**TOWN OF PORTOLA VALLEY
ARCHITECTURAL AND SITE CONTROL COMMISSION (ASCC)
Monday, August 12, 2013
Special Field Meeting (time and place as listed herein)
7:30 PM – Regular ASCC Meeting
Historic Schoolhouse
765 Portola Road, Portola Valley, CA 94028**

a. Follow-up Architectural Review for Residential Redevelopment and Site Development Permit X9H-649, 117 Pinon Drive, Divita

TO: ASCC
FROM: Tom Vlastic, Town Planner
DATE: August 12, 2013
RE: Agenda for August 12, 2013 ASCC Meeting

L5.0

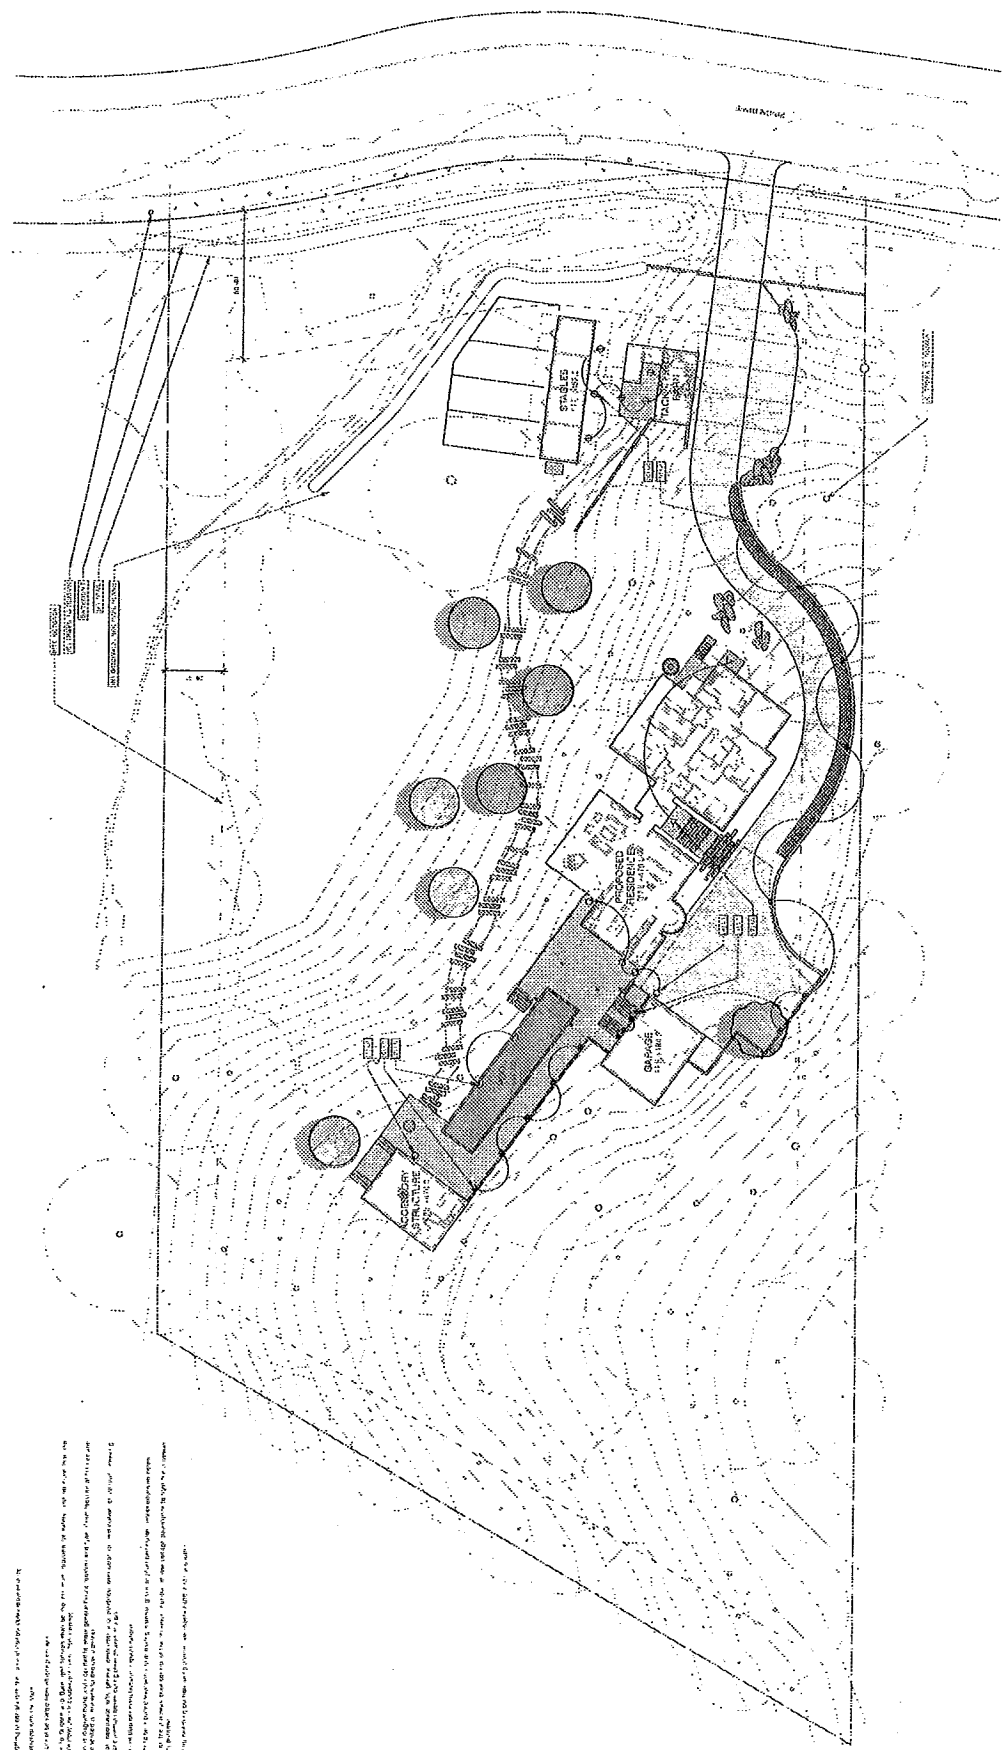
7. Exterior lighting plan. The lighting plan, sheet L-5 does not show switching patterns, but does include the modification to the bulb wattage for fixture L3. The plan does note that all lights will be controlled by switches, but patterns are not identified nor is the type of switch. Further, we note that no light is shown at the master bath door to the deck and hot tub area. We assume that either a L3 or L4 fixture would be needed at this location and the plans should be corrected to show the needed fixture.

3. Bulb wattage for fixture L3 reduced. See Sheet L5.0.
4. Landscape Plan revised. See Notes Sheet L3.0.
5. Chimney height reduced. Measurements and dimensions of direct vent system of gas fireplace detailed per manufacturers specifications. See 2/A311.

④ FIREPLACE VENT SECTION
3'-0" x 1'-0"

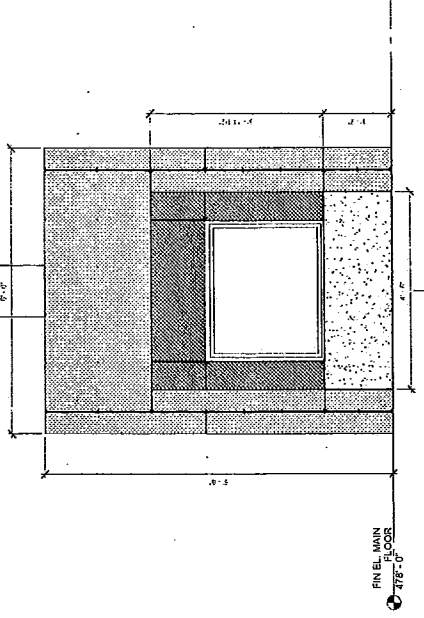
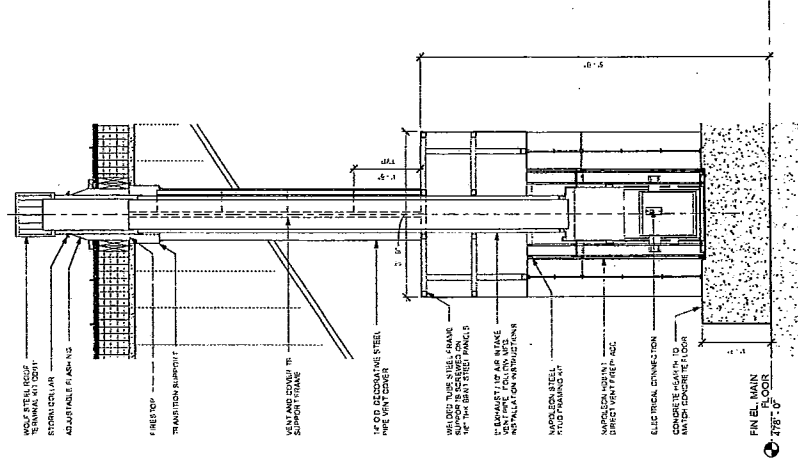
6. **Clarify bedroom wing skylight material and internal lighting.** Provide plan clarifications consistent with comments offered at the ASCC meeting.
7. **Chimney height.** The chimney height as viewed in the plan elevations on Sheet A201 seems more than is needed for conformity to building code requirements. The height should be no more than needed for code compliance.

L-1

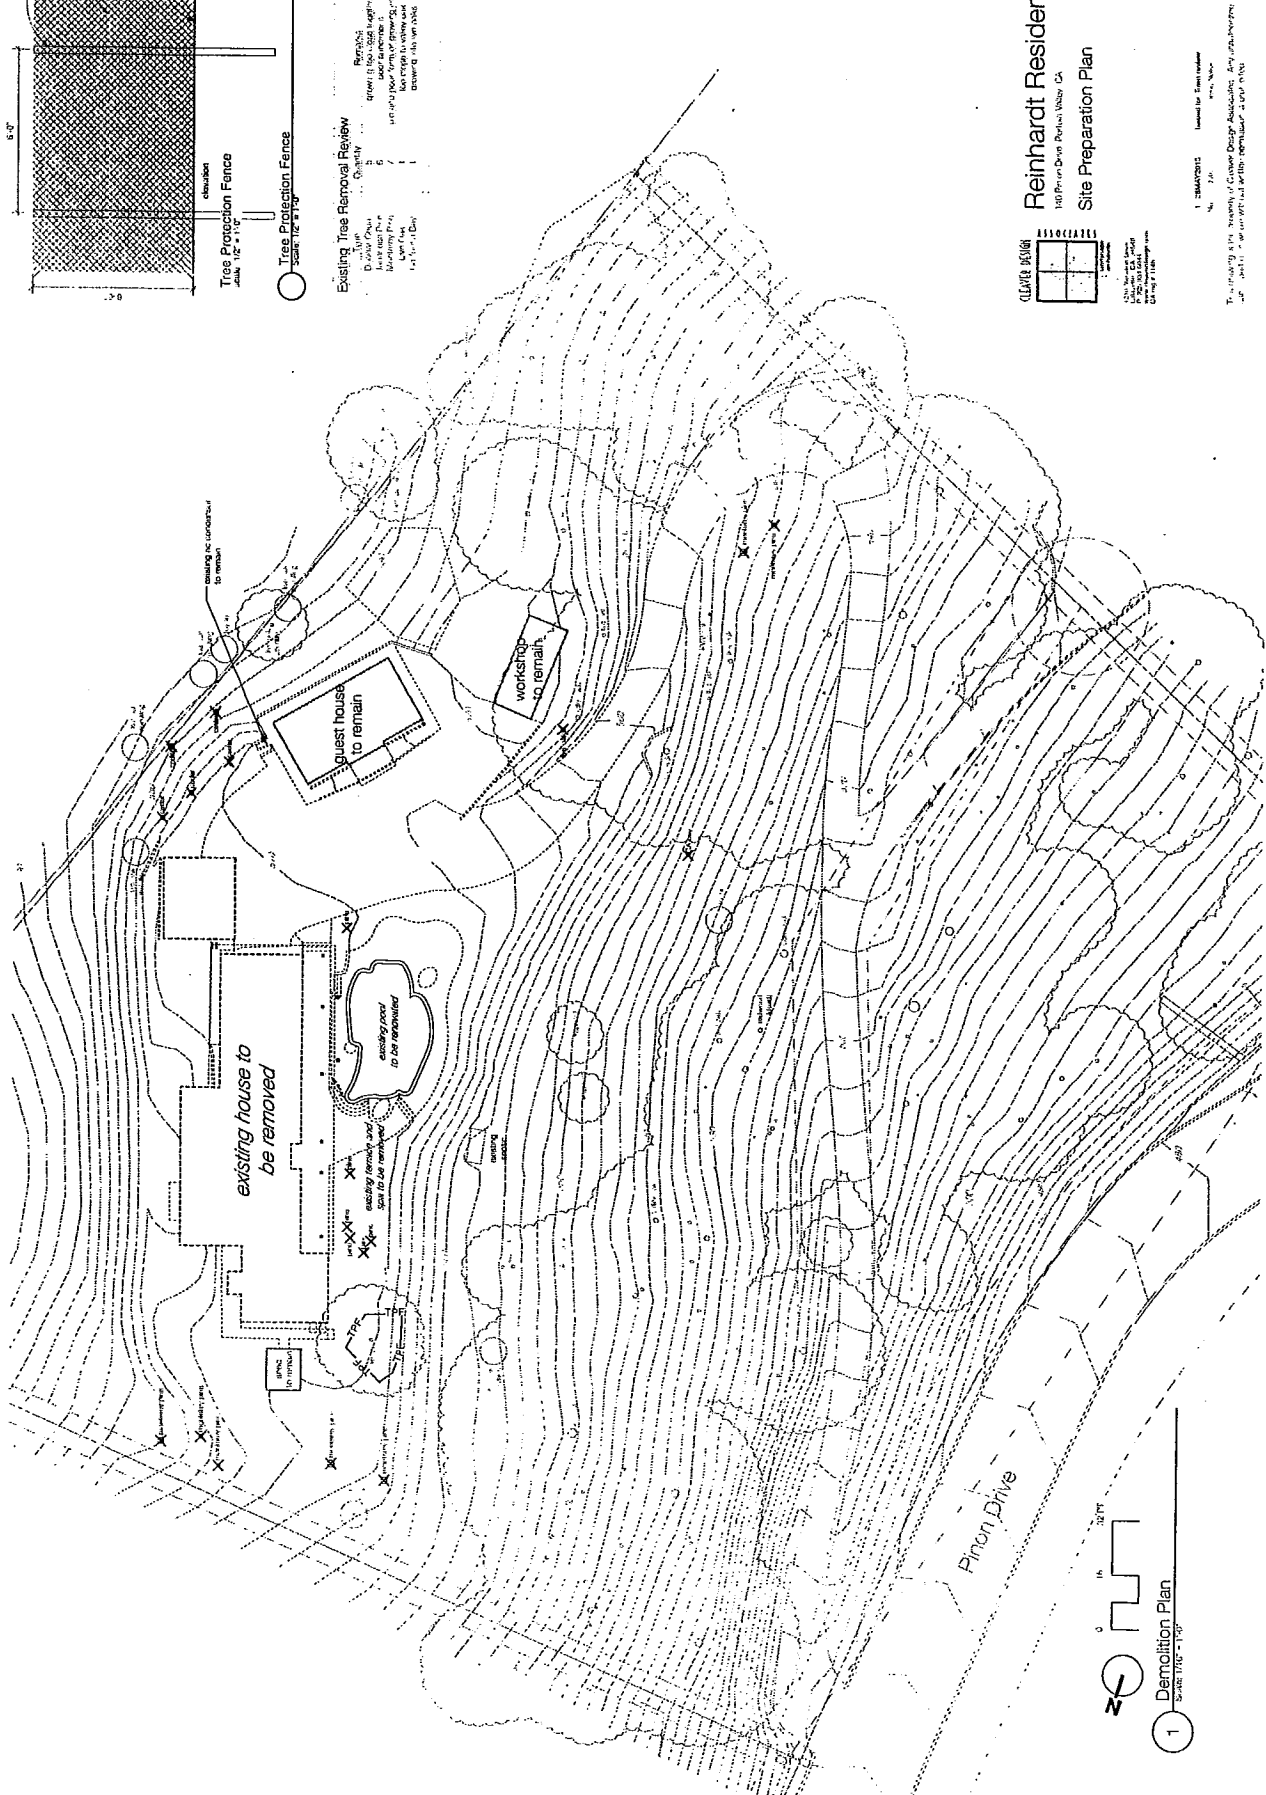
As shown on Sheet L-1, a number of existing pines, cedars, one dead redwood, and one bay would be removed. In addition, one small live oak is to be removed. It is immediately west of the boat house/workshop, and removal is proposed due to proximity of the tree to a valley oak. The conservation committee has considered the proposed tree removal and supports it as commented on in the attached July 1, 2013 report.

A1.0

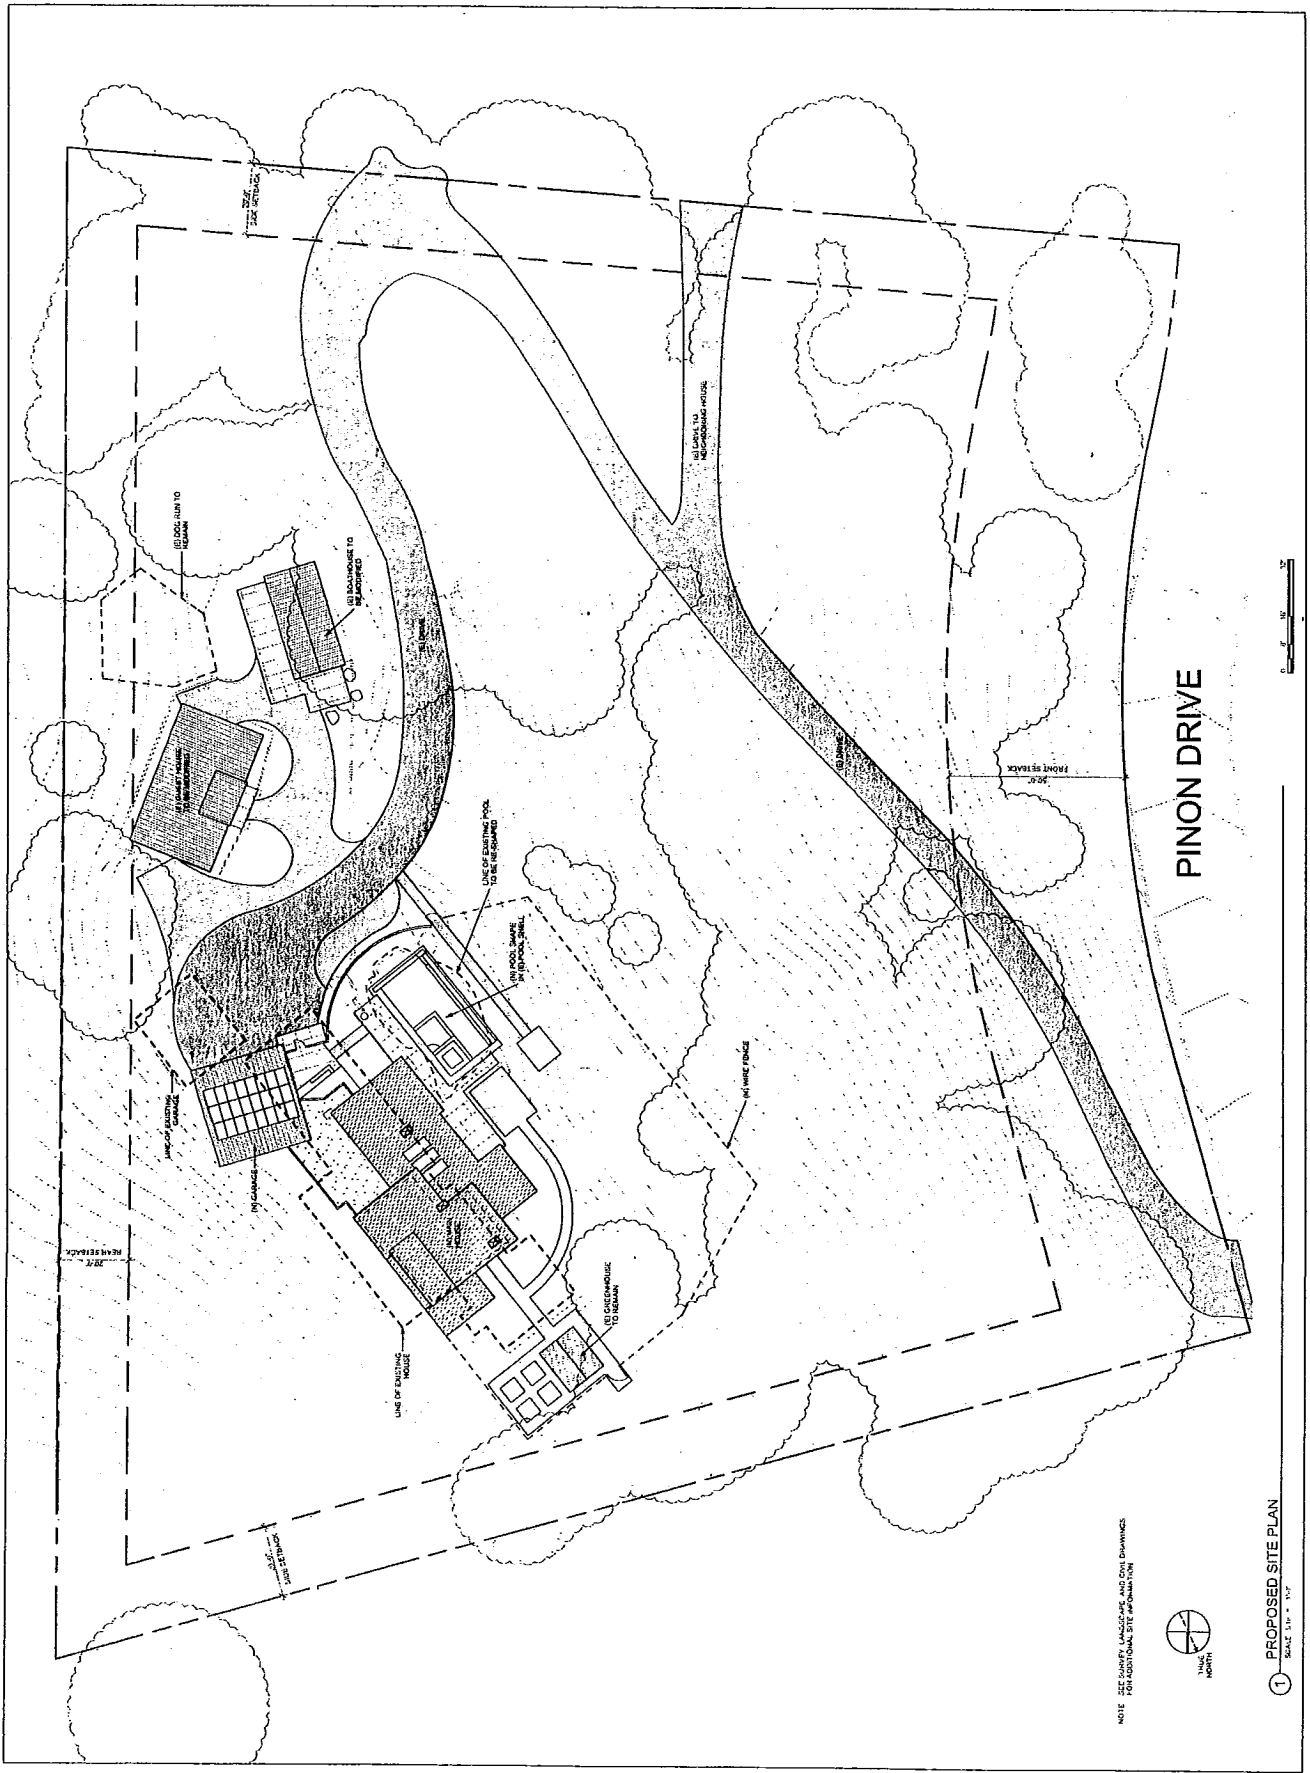
Compliance with required yard setbacks is demonstrated on plan Sheet A1.0. AS can be seen from this sheet, the new house will meet all setback requirements and there will actually be more space between the new house and property boundaries than is the case with the existing house and detached garage.

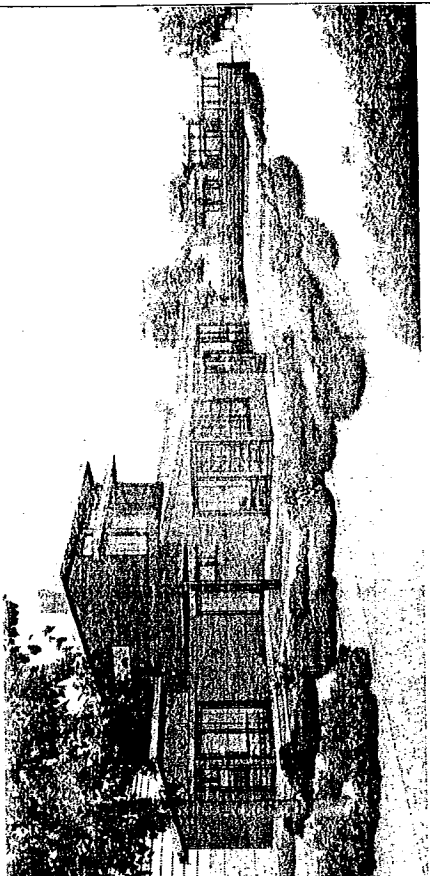
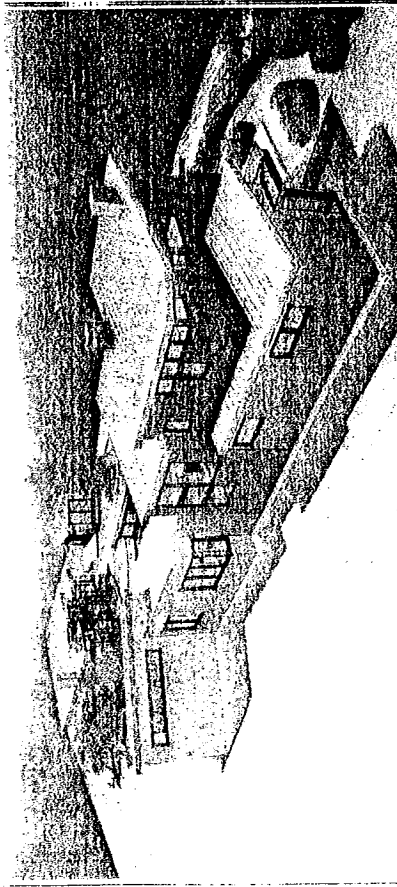
4. **Project Design and Exterior Materials.** The proposed architecture was discussed above and is best appreciated from review of the plan elevation and 3D view sheets (i.e., Sheets A3.0, A3.1 and A6.0). The design incorporates low pitch roof forms, and a variety of architectural details that add interest, and shadow patterns and also helps ensure minimum potential for excess massing or scale. The proposed finish treatments for the house, guest house and boat house/workshop remodeling include:
